**Addendum No. 3**

**Final Environmental Impact Report  
for Metro Gold Line Foothill Extension - Azusa  
to Montclair (SCH 2010121069)**

**Evaluating Minor Design Changes of the Project  
Azusa to Montclair**

Metro Gold Line Foothill Extension Construction Authority  
March 2016

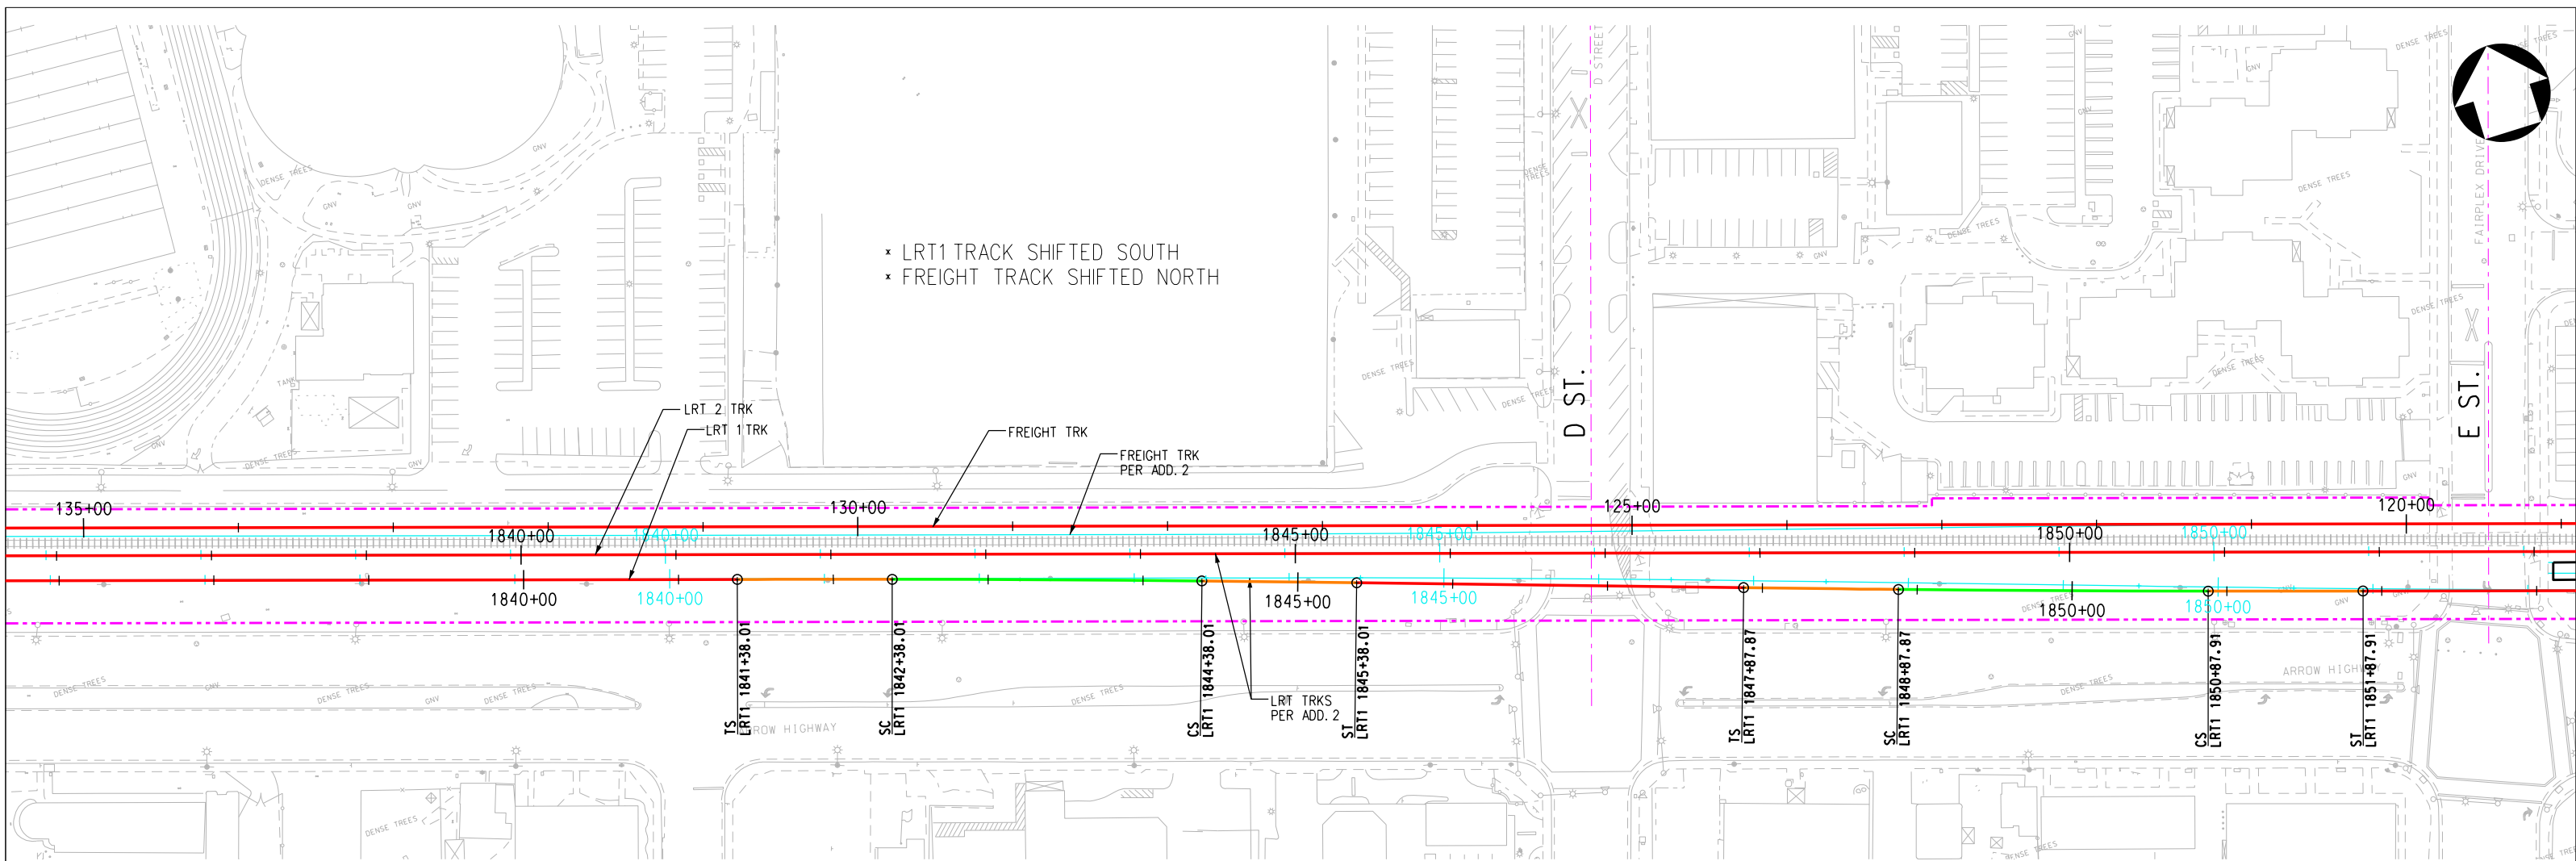
- \* LRT1 TRACK SHIFTED SOUTH
- \* FREIGHT TRACK SHIFTED NORTH

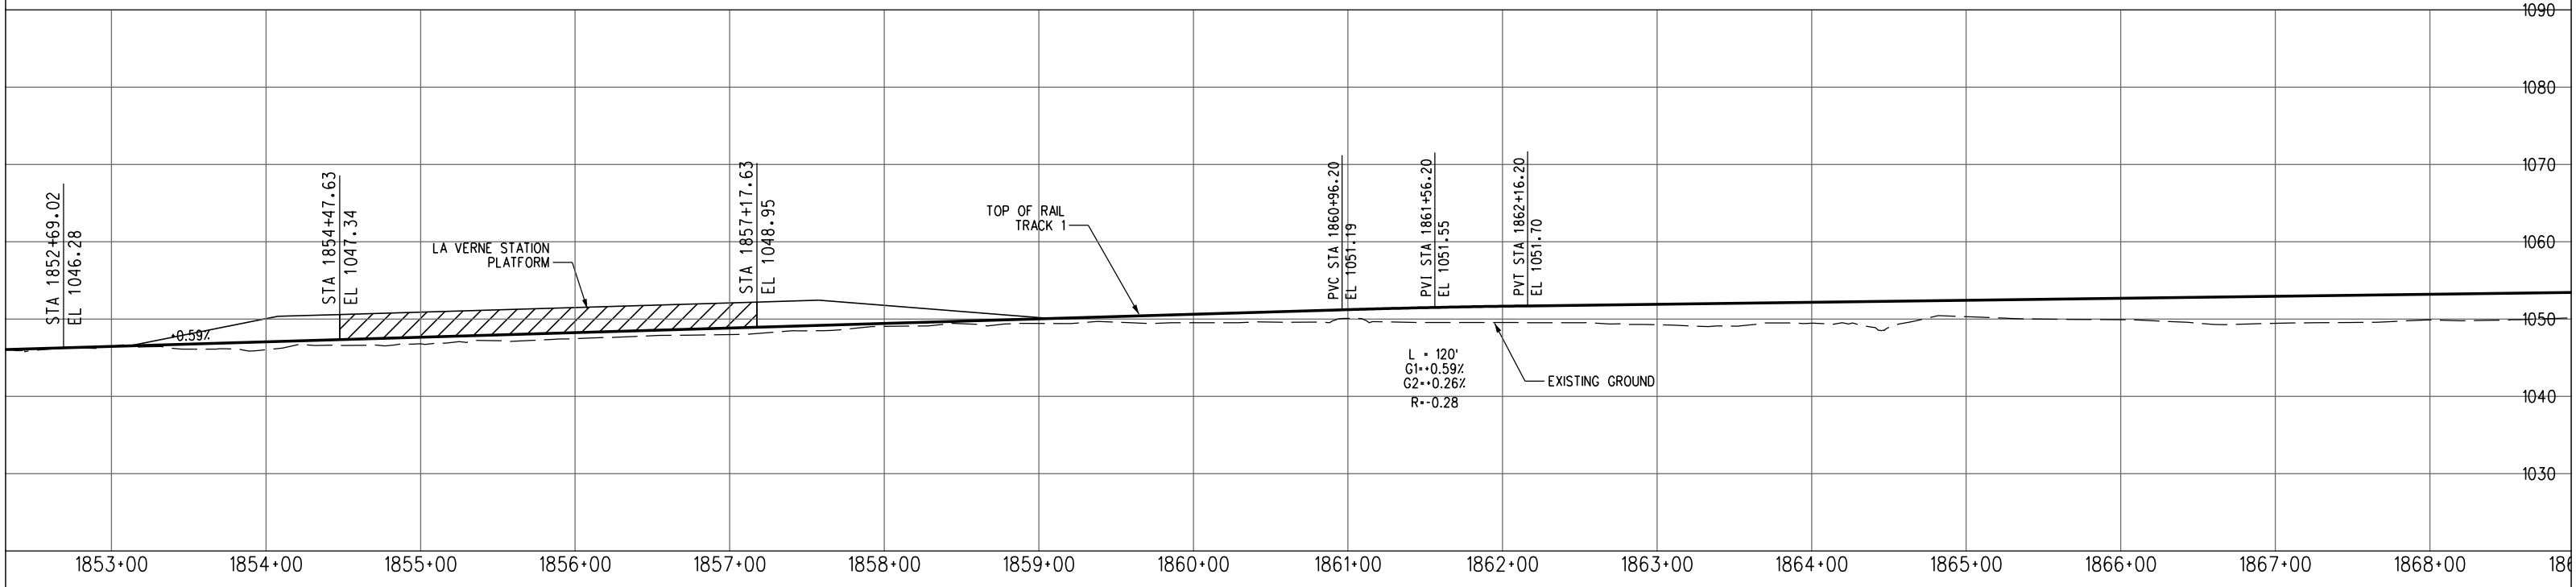
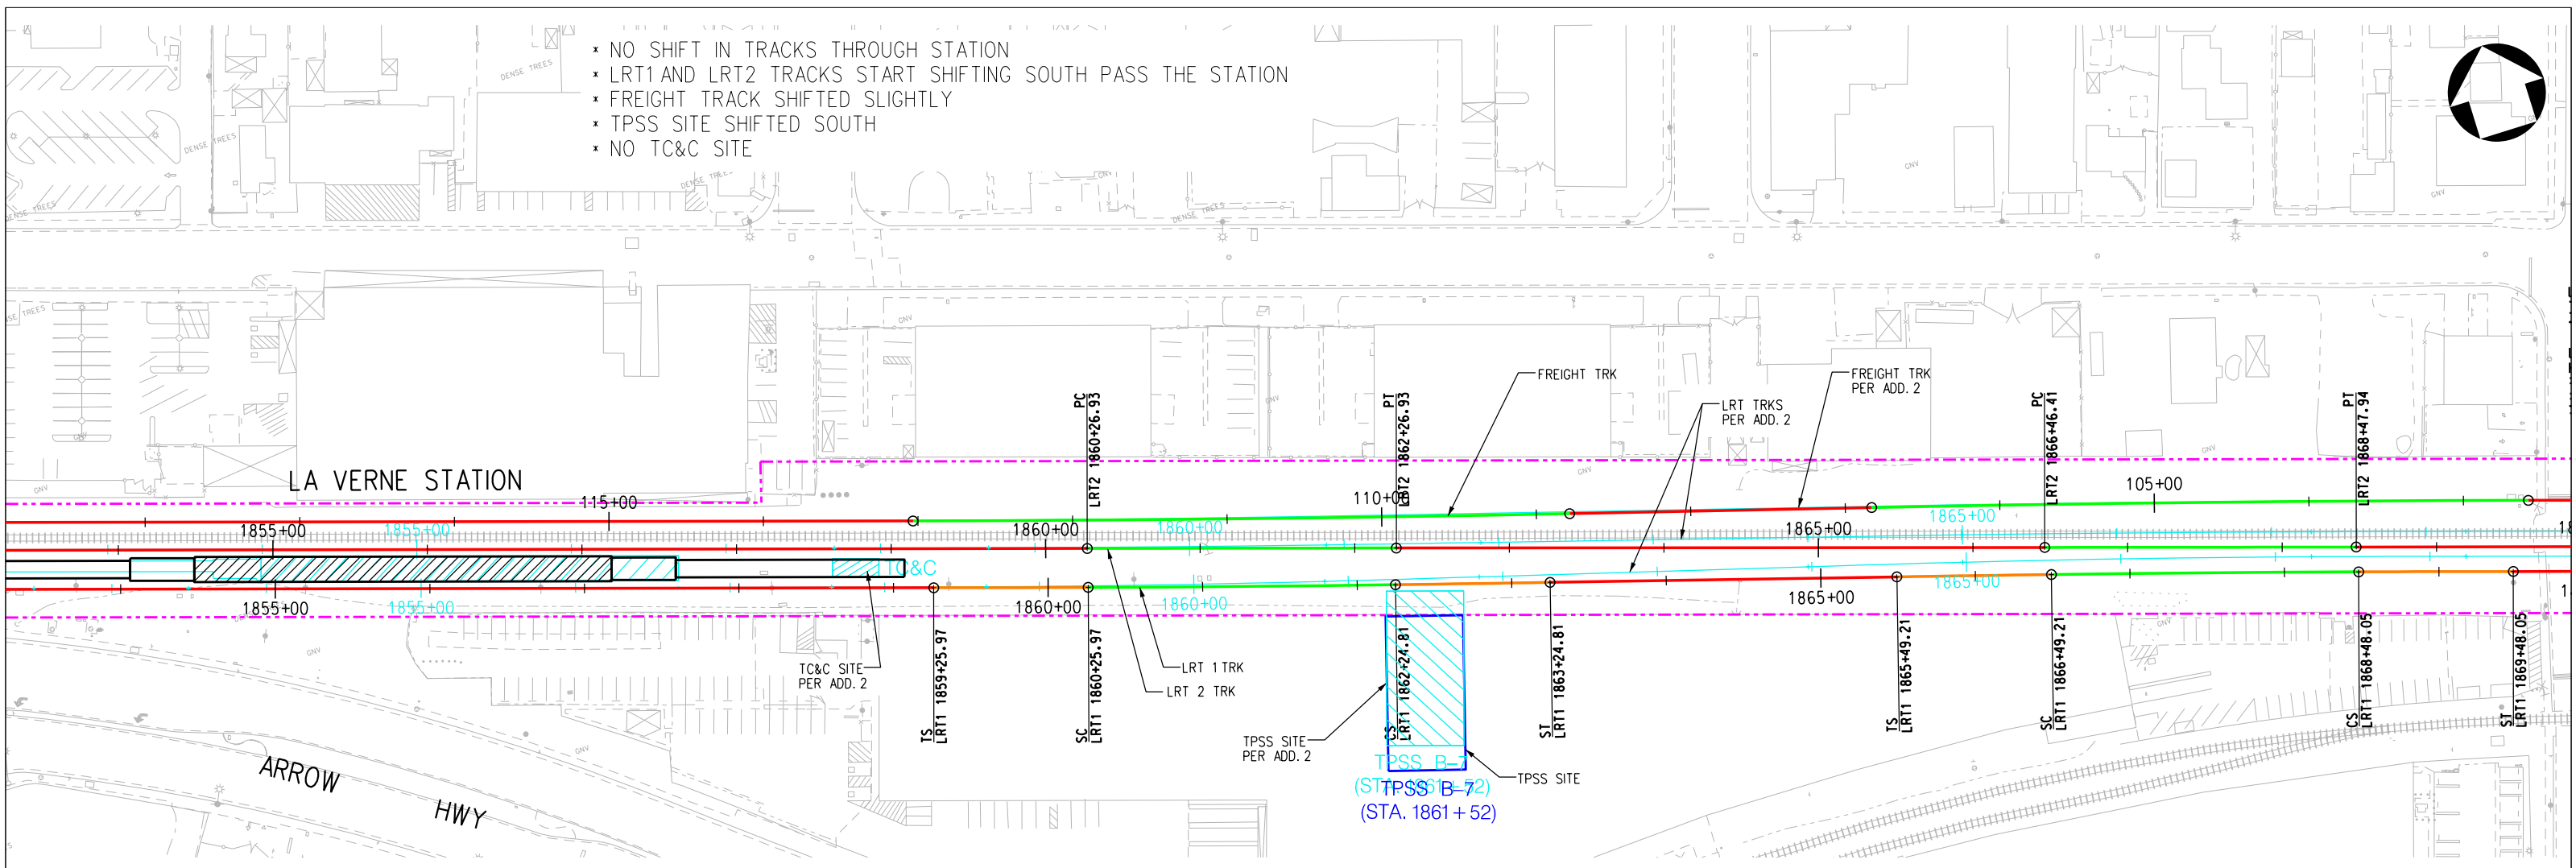
- × NO SHIFT IN TRACKS THROUGH STATION
- × LRT1 AND LRT2 TRACKS START SHIFTING SOUTH PASS THE STATION
- × FREIGHT TRACK SHIFTED SLIGHTLY
- × TPSS SITE SHIFTED SOUTH
- × NO TC&C SITE

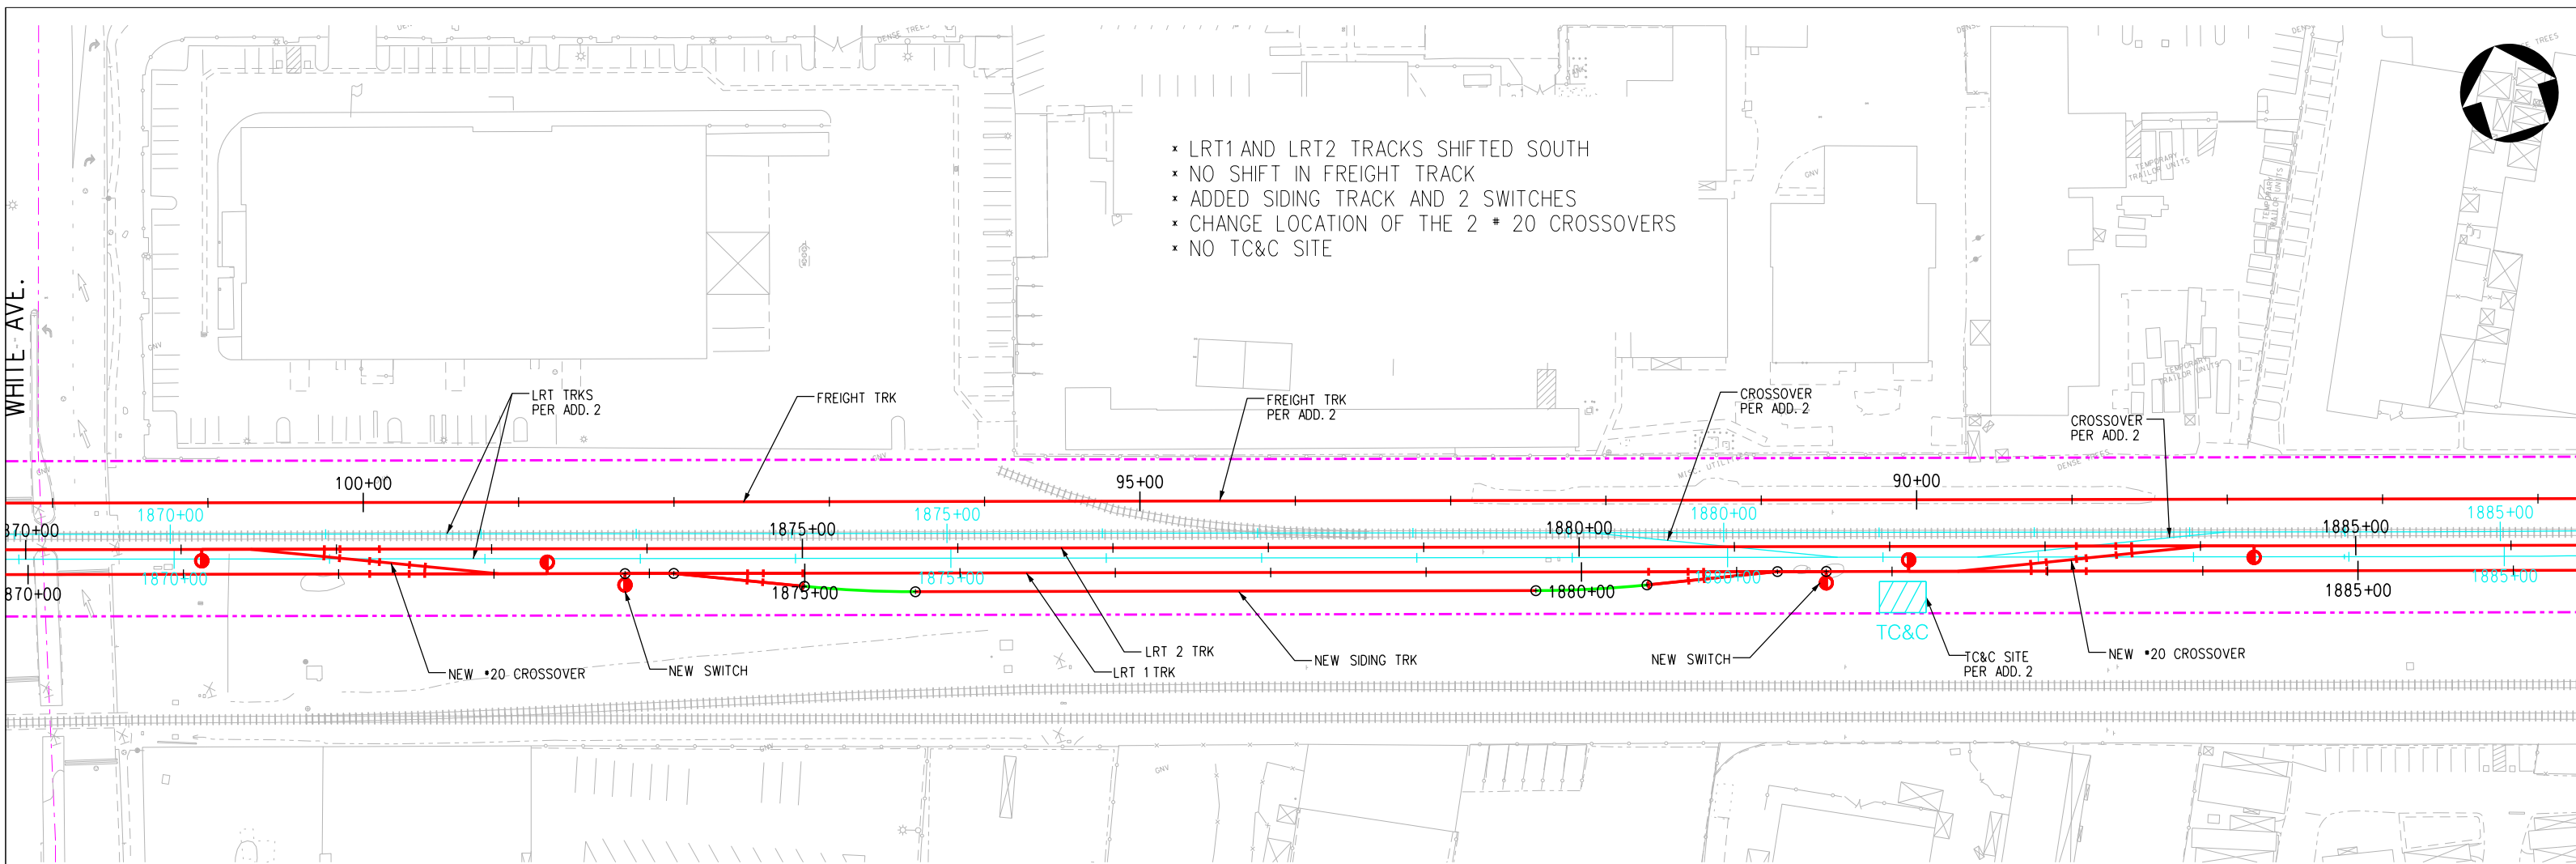
- \* LRT1 AND LRT2 TRACKS SHIFTED SOUTH
- \* NO SHIFT IN FREIGHT TRACK
- \* ADDED SIDING TRACK AND 2 SWITCHES
- \* CHANGE LOCATION OF THE 2 # 20 CROSSOVERS
- \* NO TC&C SITE
